ACCESSION NBR: 8102030399 DOC. DATE: 81/01/22 NOTARIZED: NO
 FACIL: 50-287 Oconee Nuclear Station, Unit 3, Duke Power Co.
 AUTH. NAME: PARKER, W.O. AUTHOR AFFILIATION: Duke Power Co.
 RECIP. NAME: DENTON, H.R. RECIPIENT AFFILIATION: Office of Nuclear Reactor Regulation, Director

SUBJECT: Responds to NRC 810112 ltr requesting addl info re Cycle 6 reload. All fuel assemblies in Cycle 6 core have been insp. All fuel assemblies in Cycle 5 core were insp before fuel shuffle for Cycle 6. No defective springs were observed.

Responses to Request
For Additional Information

Oconee Nuclear Station
Unit 3

DNBR PENALTY vs BURNUP

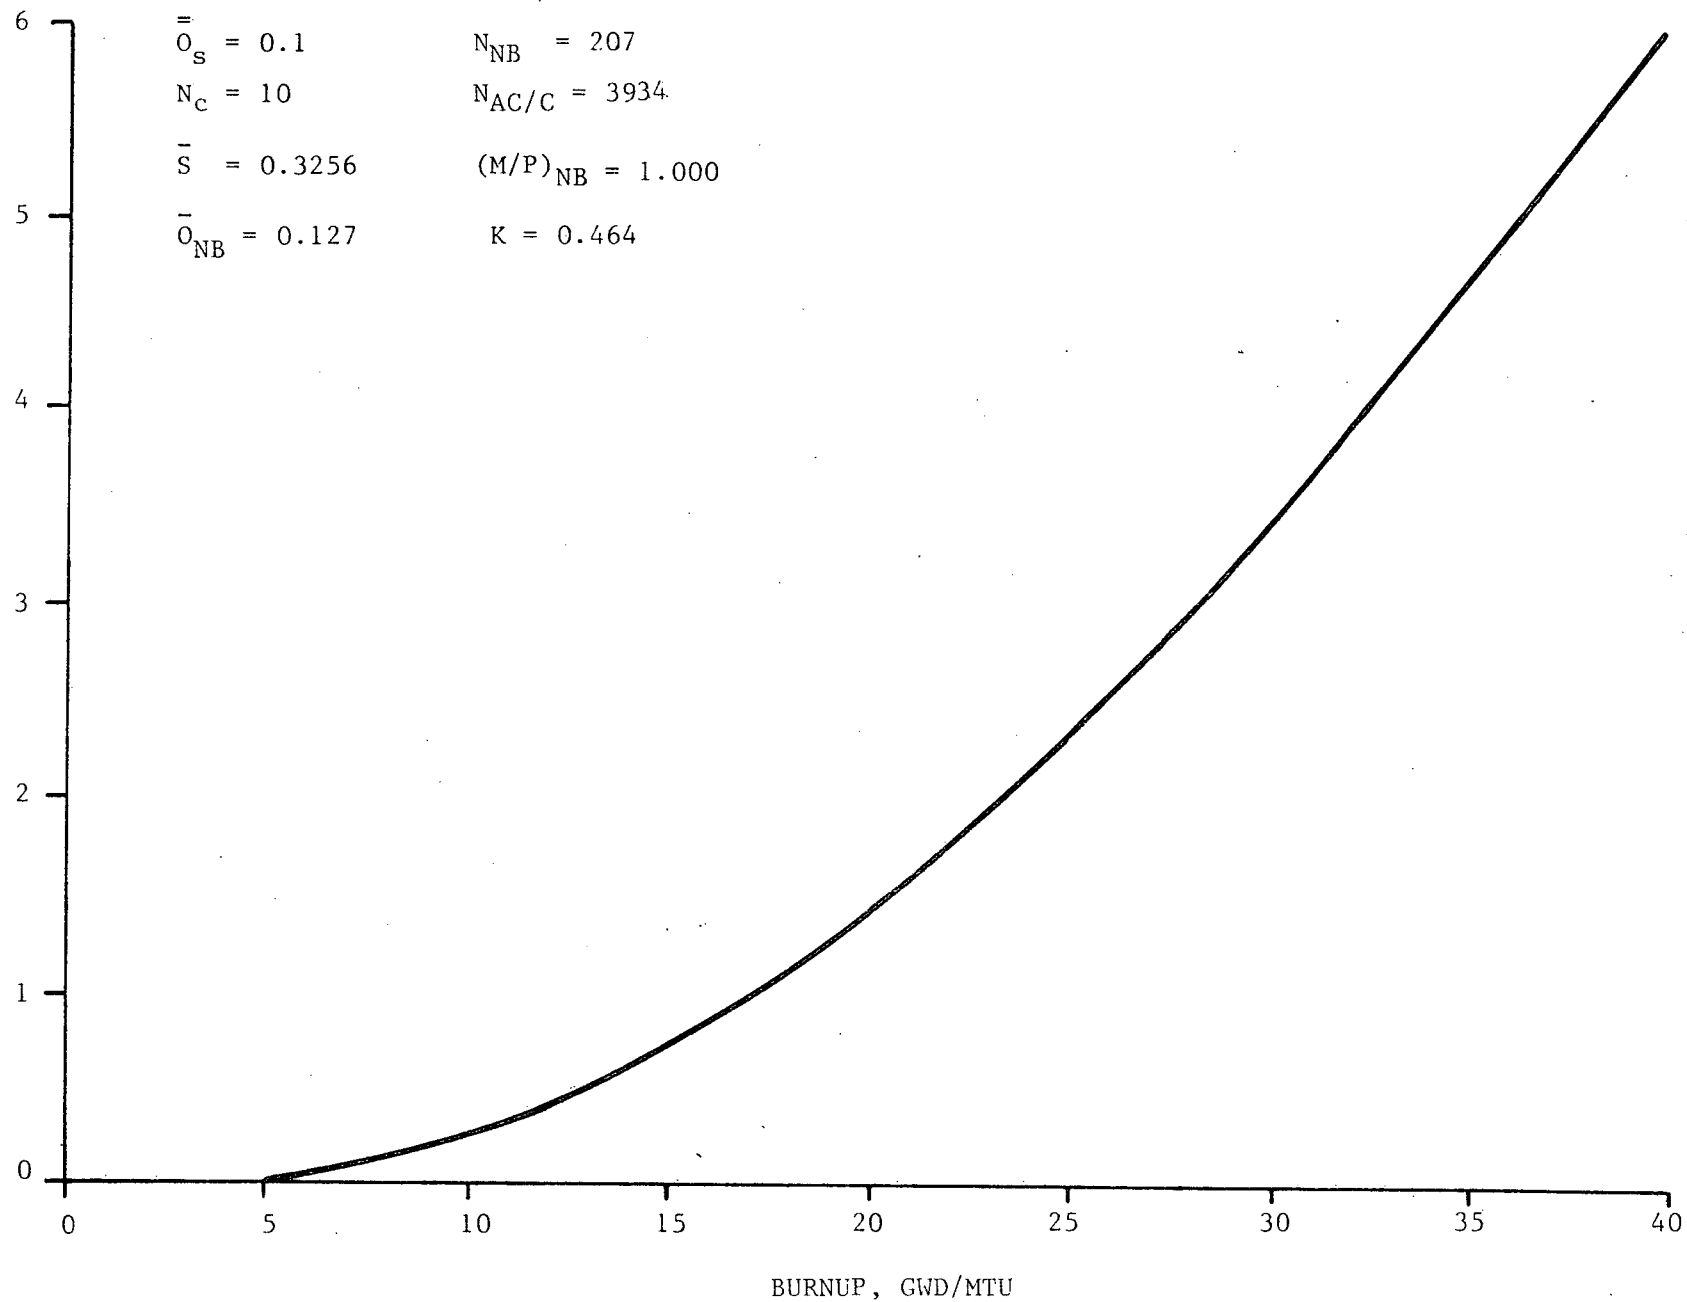
- (a) Please provide the details of this calculation. Specifically, what were the values of:

K , $\sigma(\Delta c/c)$, $F(k/\sigma)$, $F(k/\sigma)$, \bar{U} ,

95 x 95

σ_u , σ_{δ} , $\bar{\delta}$, $N_{\delta-1}$, σ_b , N_{b-1} and $DNBR_b$

- (a) Please find the attached curve and intermediate points from Babcock and Wilcox used to obtain these values. (Attachment 1)
- (b) The magnitude of credit taken for the flow-area reduction hot channel factor is 1%.
- (c) Yes, the margins used to offset the rod bowing DNBR penalty are employed solely for this purpose.
- (d) The generic margin is included in the attached (Attachment 2) proposed revision to Oconee Technical Specification page 2.1-3d.

The rod bow DNBR penalty as a function of burnup is plotted on the attached curve. This curve was generated by the method described in Reference 1. The only change is that the value for K used in the sample calculation is 0.55 and the value for K used in the calculations generating the curve is 0.464. The value for K was calculated by the method outlined in Reference 2 using a DNBR penalty of 5.2% at 55 percent closure as described in Reference 3. The attached figure is a plot of the rod bow DNBR penalty vs. burnup and includes a summary of the parameters used in the calculation.
